Final Subsequent Environmental Impact Report

# Sunshine Canyon Landfill

State Clearinghouse Number 92041053

**October 1998**

FIGURE NO. **4.3-2 (REVISED)**

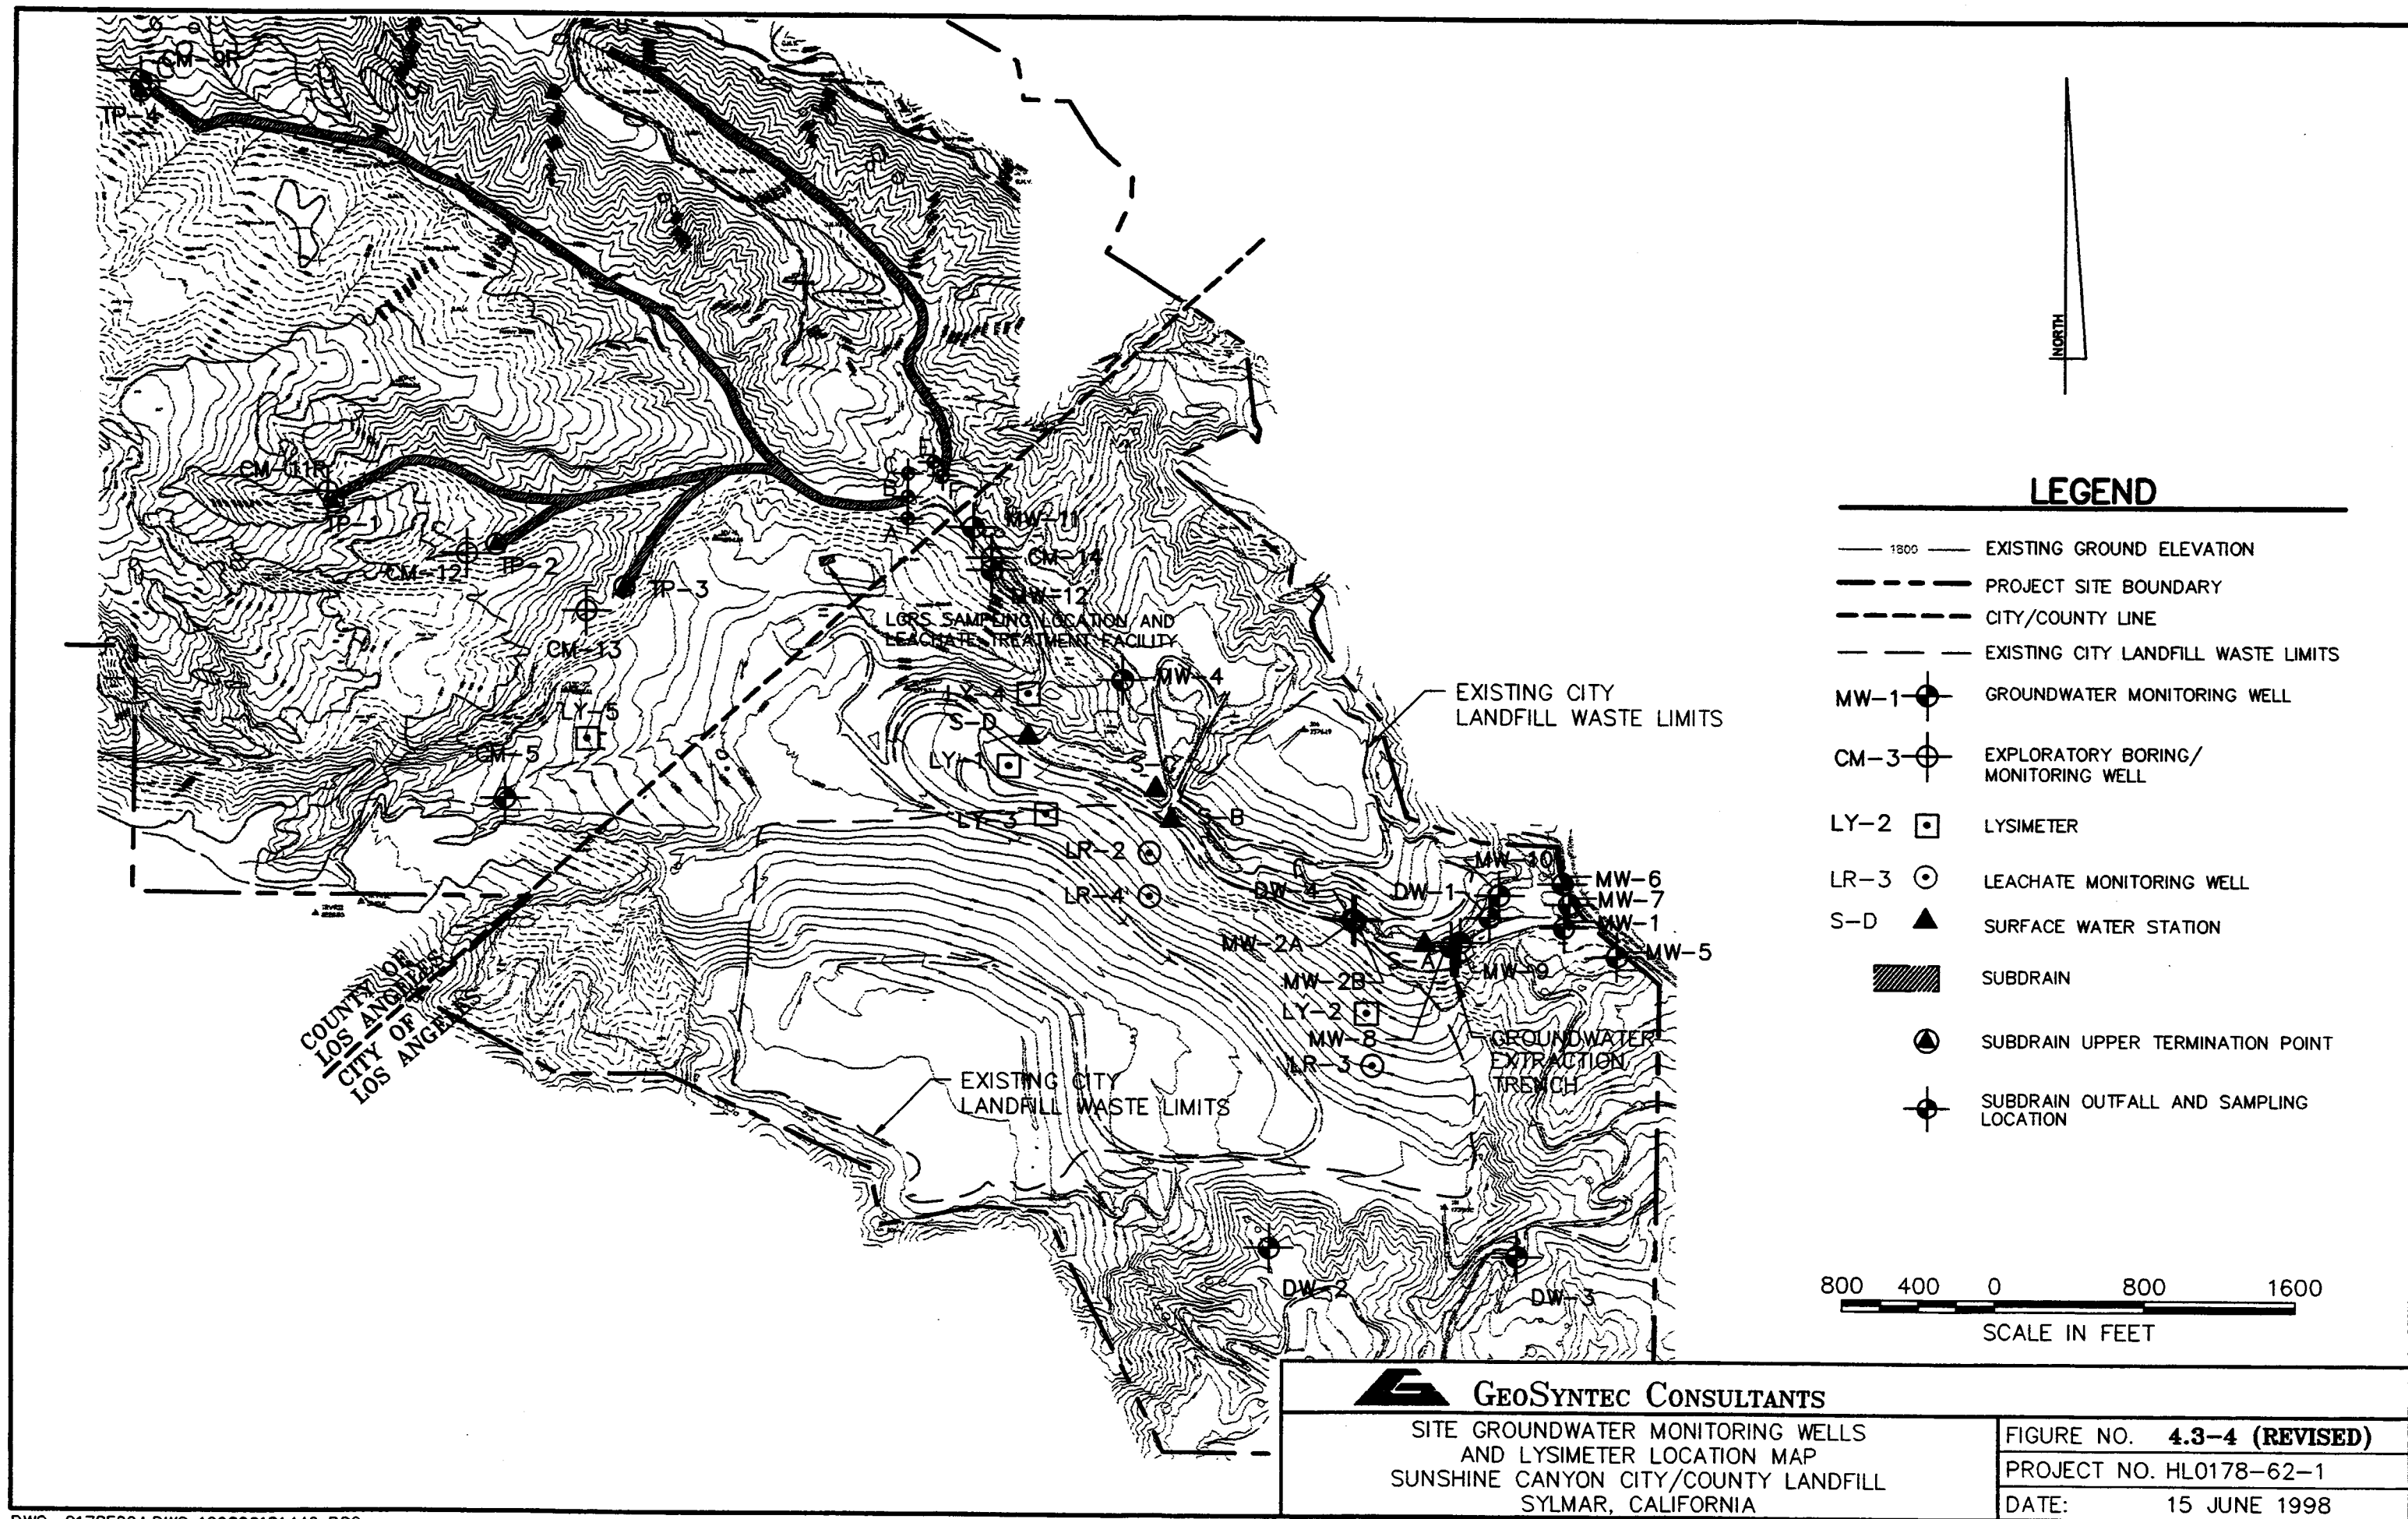
Section 4.3.1, Surface Water, Figure 4.3-2, p. 4-107

Revisions to this figure, made by the project proponent, are not in response to any of the comments included in Section 3.0 of this document.

FIGURE NO. **5.5-2 (REVISED)**

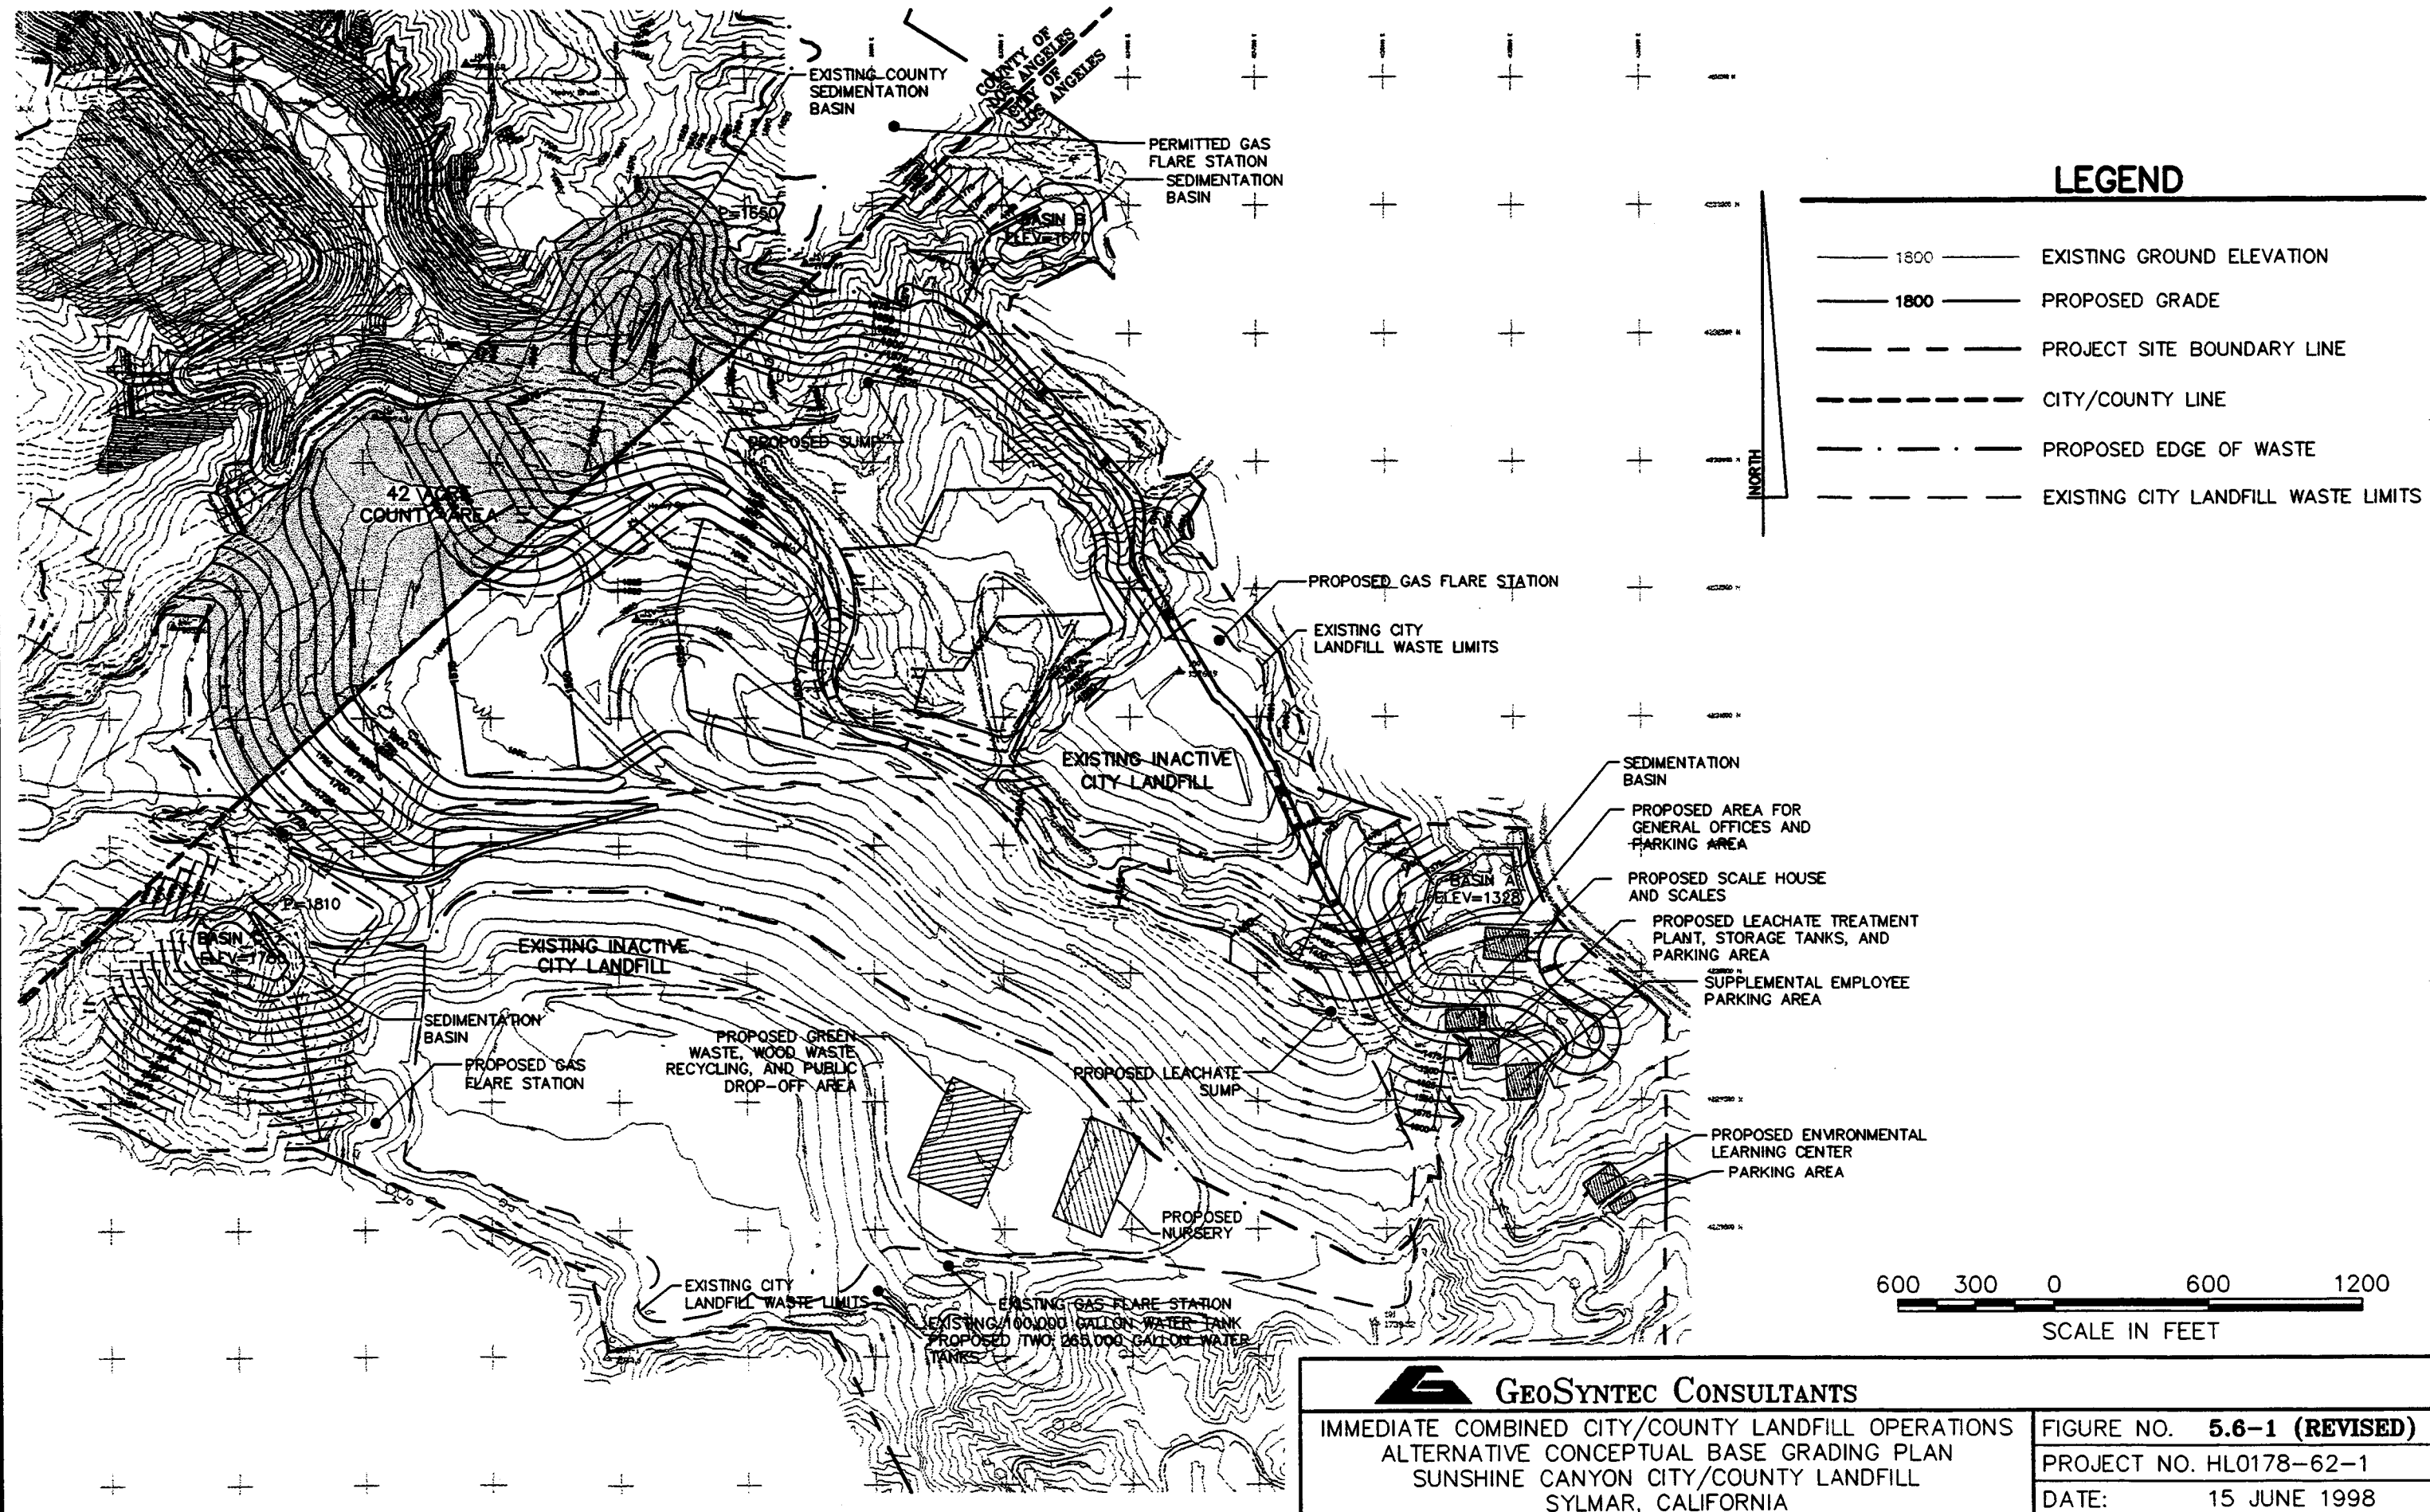
Section 5.5, Reduced Volume Alternative, Figure 5.5-2, p. 15

These changes, made by the project proponent, are not in response to any of the comments included in Section 3.0 of this document.
